SHIRE OF SERPENTINE-JARRADALE

APPLICATION FORM (Form 2)

PLAN OR DIAGRAM NUMBER 82617 Street MUNDIJONG ROAD

Building Application No: 60/97

SUBJECT: *Amended Irrigation Area.*

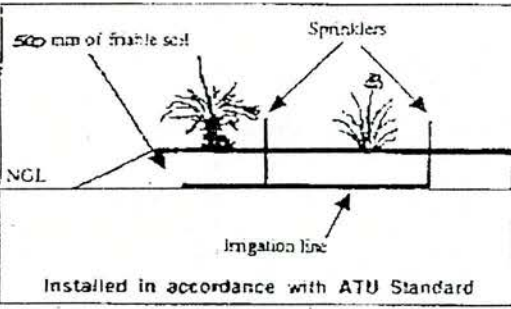
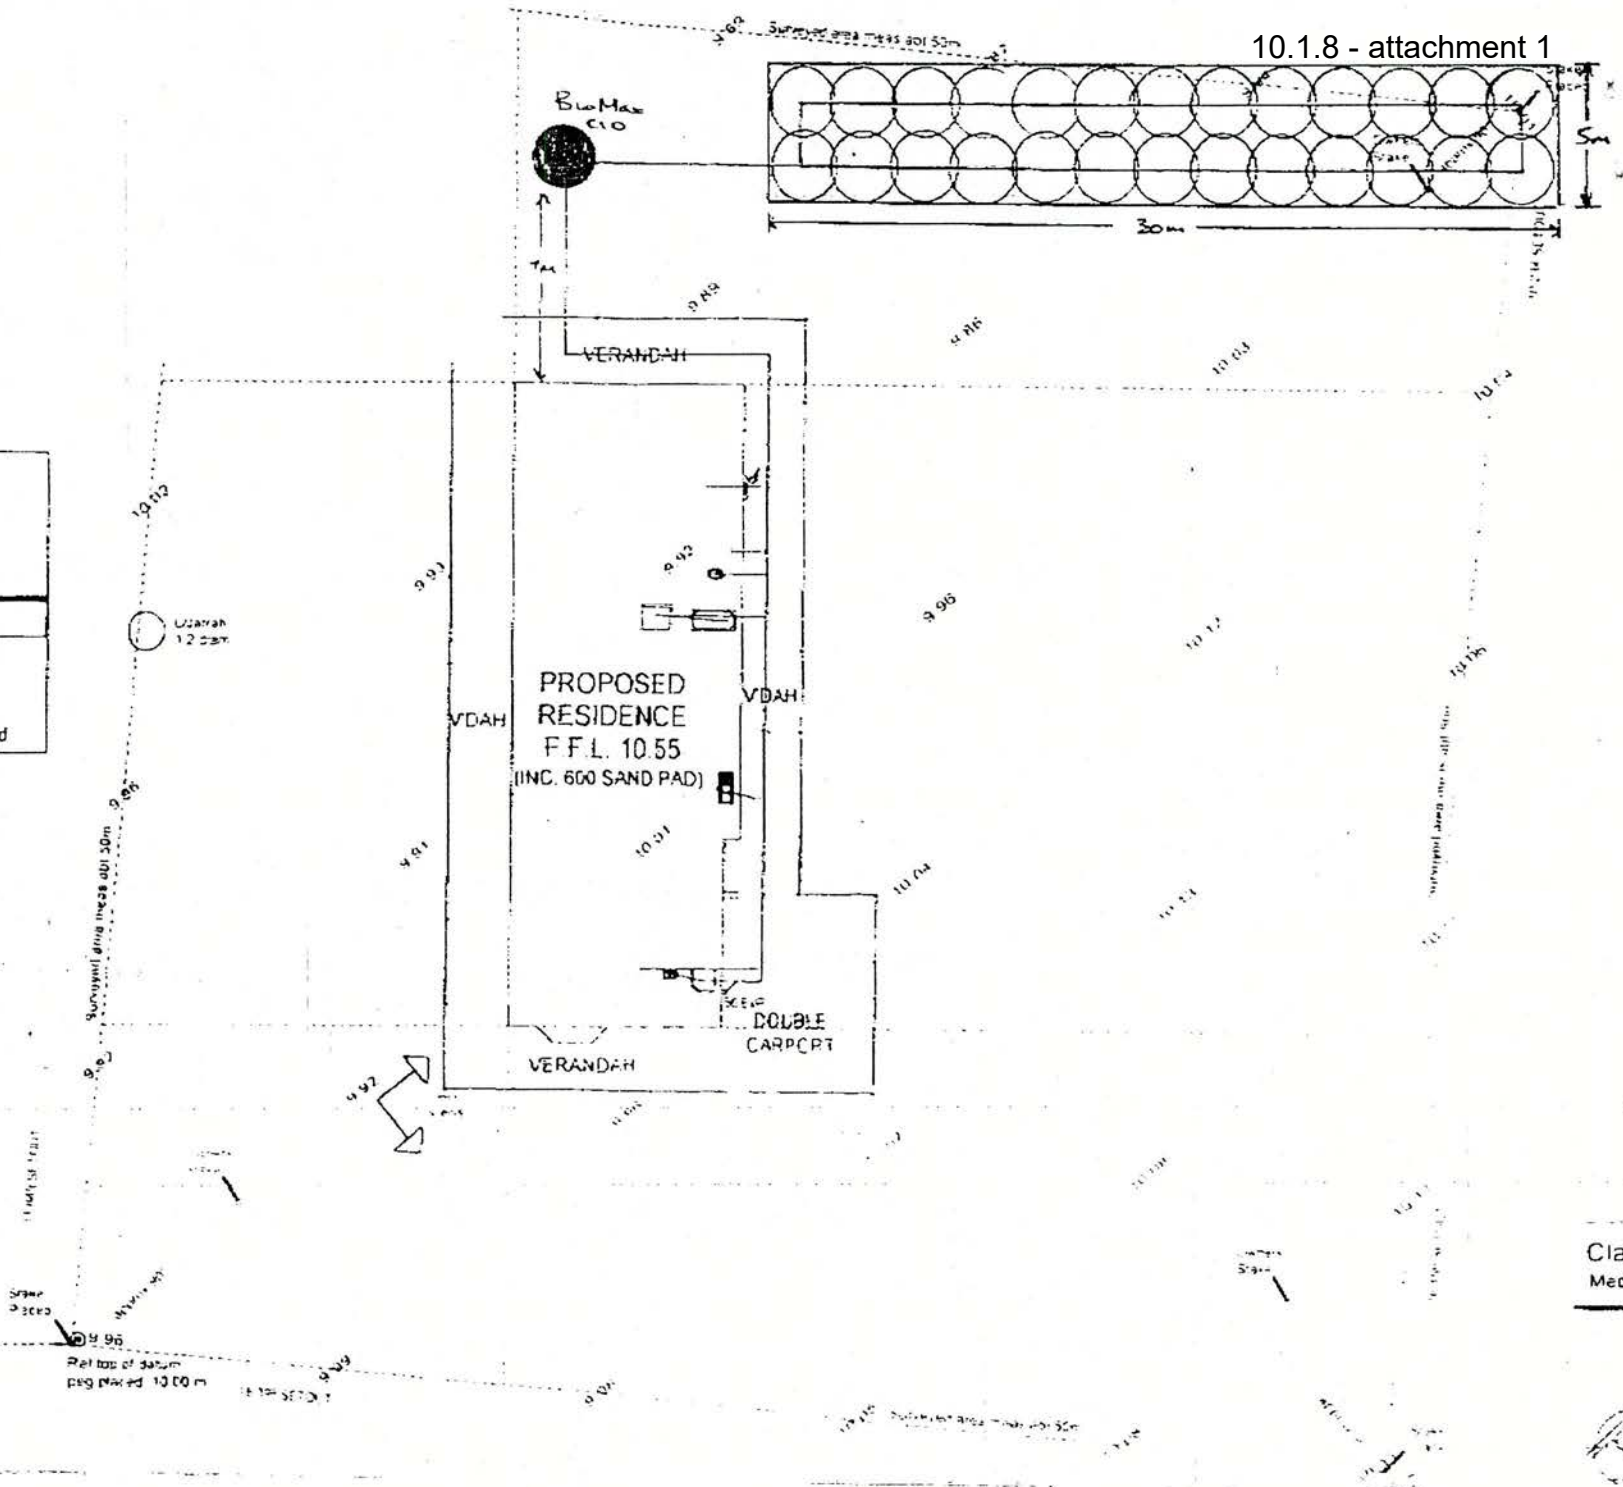
Amended plan for lot 101

Mundijang Road, Peel Estate.

MAIN ROADS WESTERN AUSTRALIA
 THE LAND REQUIREMENT SHOWN IN THIS DRAWING MAY NOT REPRESENT THE EXISTING M.R.S. RESERVATION
 EXTRACT M.R.W.A. DRG. No. 9721-008 + 009
 SCALE 1:2000 DIMENSIONS SUBJECT TO SURVEY
 FILE DATE 26/3/97

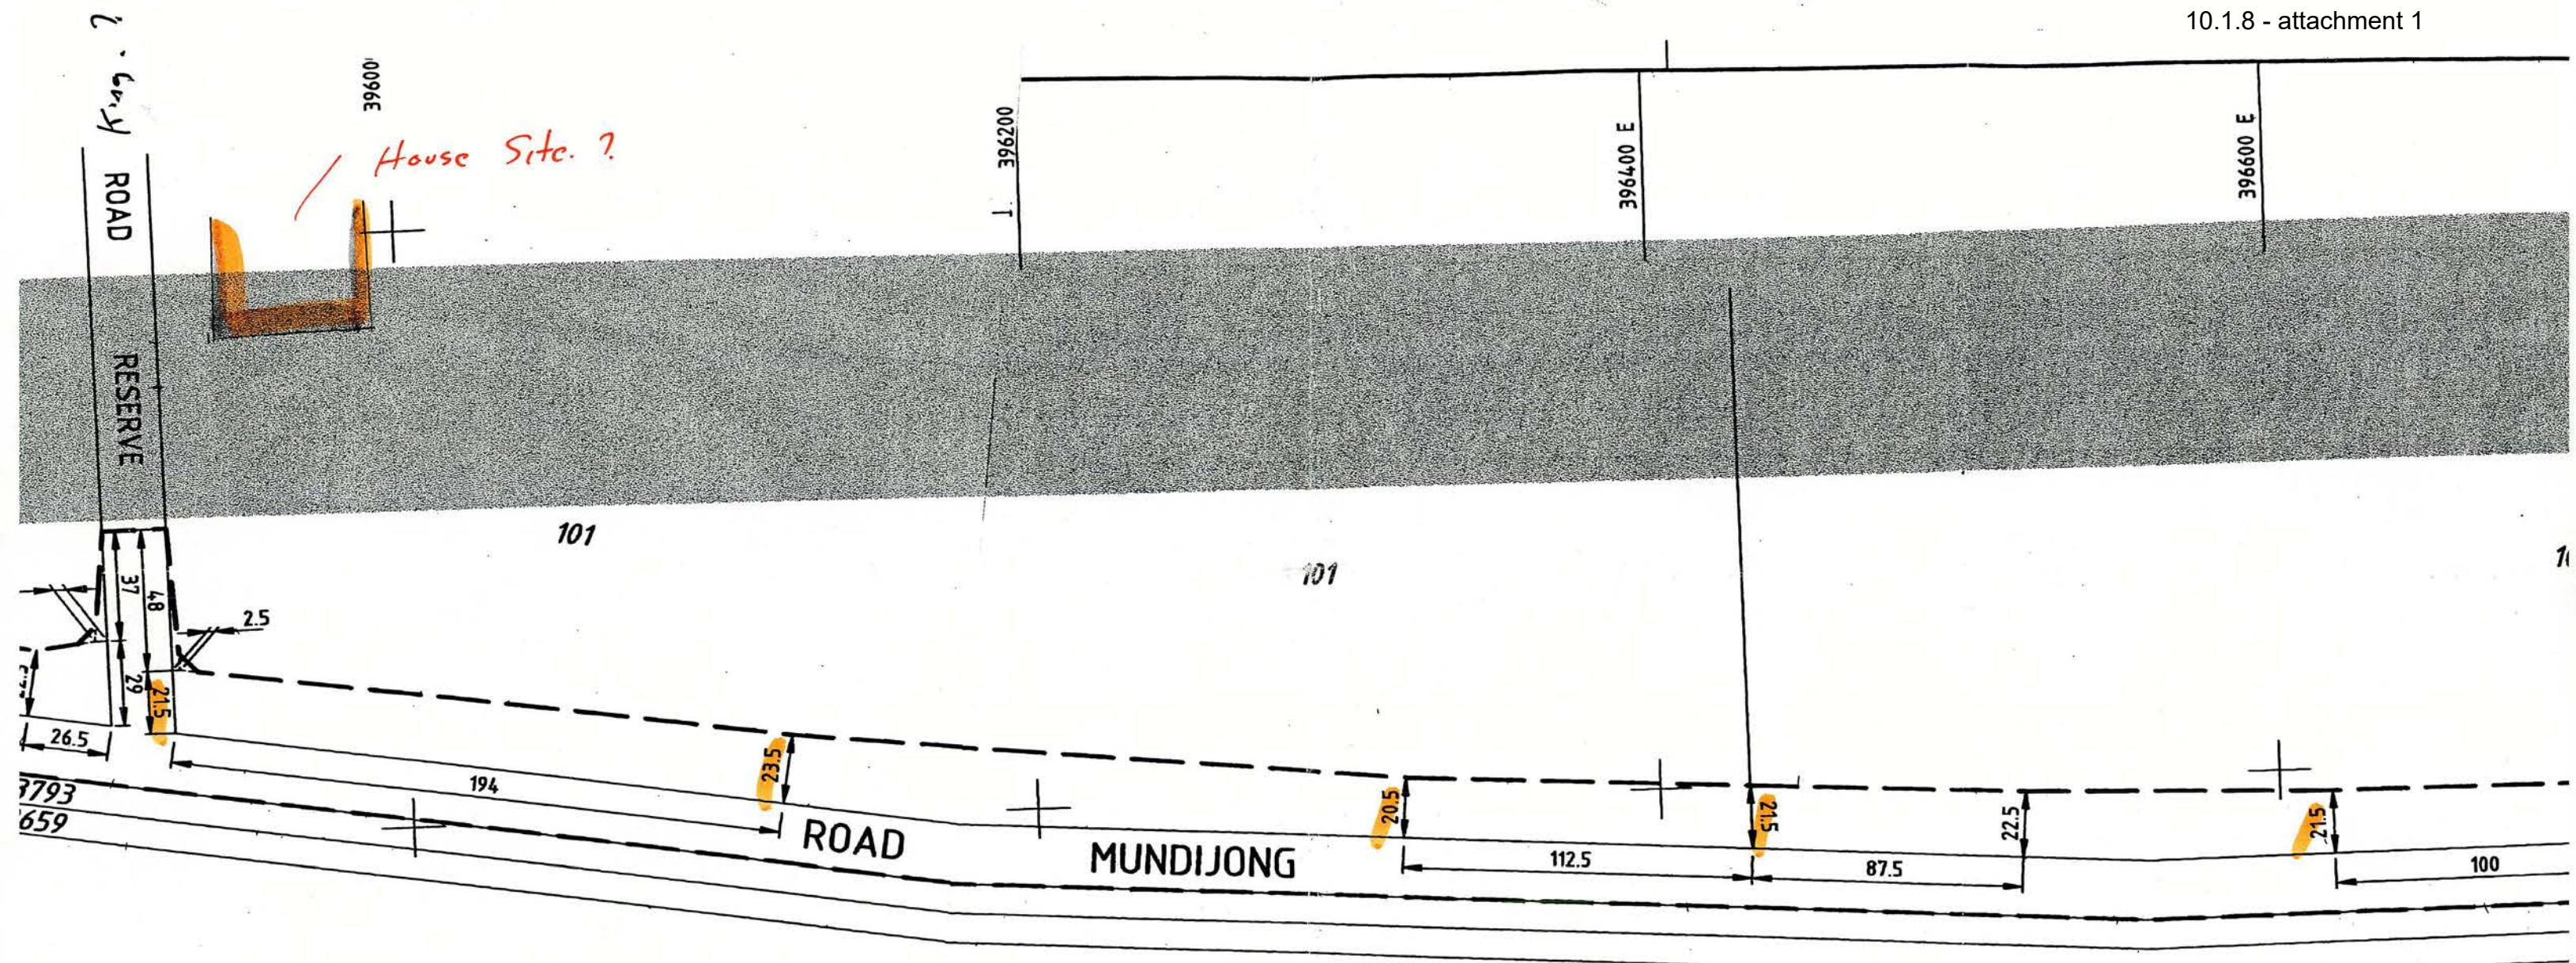
However, Main Roads in consultation with the Ministry for Planning has undertaken a planning study to redefine this route. This proposal allows for the widening of the existing road reservation as shown on the attached extract of Main Roads Drawings Nos 9721-008 and 009.

However, Main Roads in consultation with the Ministry for Planning has undertaken a planning study to redefine this route. This proposal allows for the widening of the existing road reservation as shown on the attached extract of Main Roads Drawings Nos 9721-008 and 009.

If this Amendment is adopted by the relevant authorities then the proposed location of the house is acceptable.

BATH

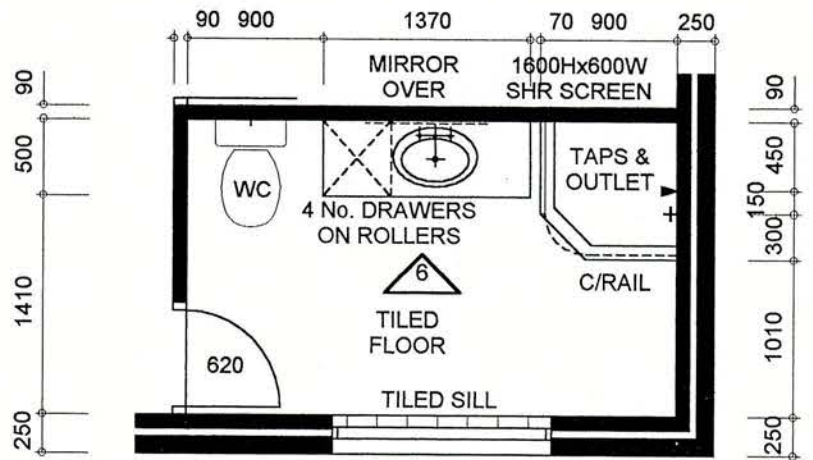
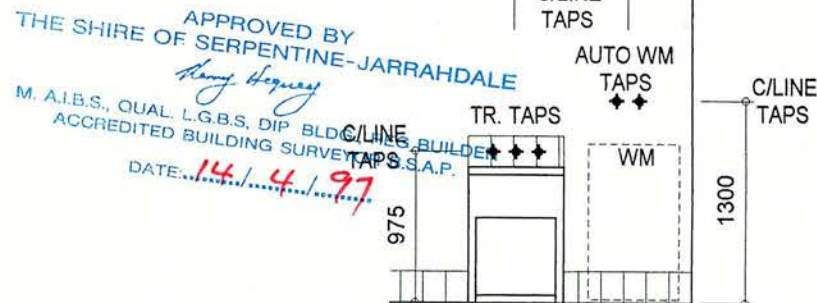
REMARKS REQUIRE ① FLUME + FAN OVER HOT PLATE. ② SELF-CLOSING DOOR - ENSUITE. ③ FANS ABOVE VENTS IN MAIN WC & ENSUITE.

- ① ~~Fume vent fans required in ensuite.~~ ^{DELETE - NOT detailed on approved plan.}
- ② Self-closing door required - ensuite.
- ③ Fans required in main WC & ensuite when fume vents have already been installed.
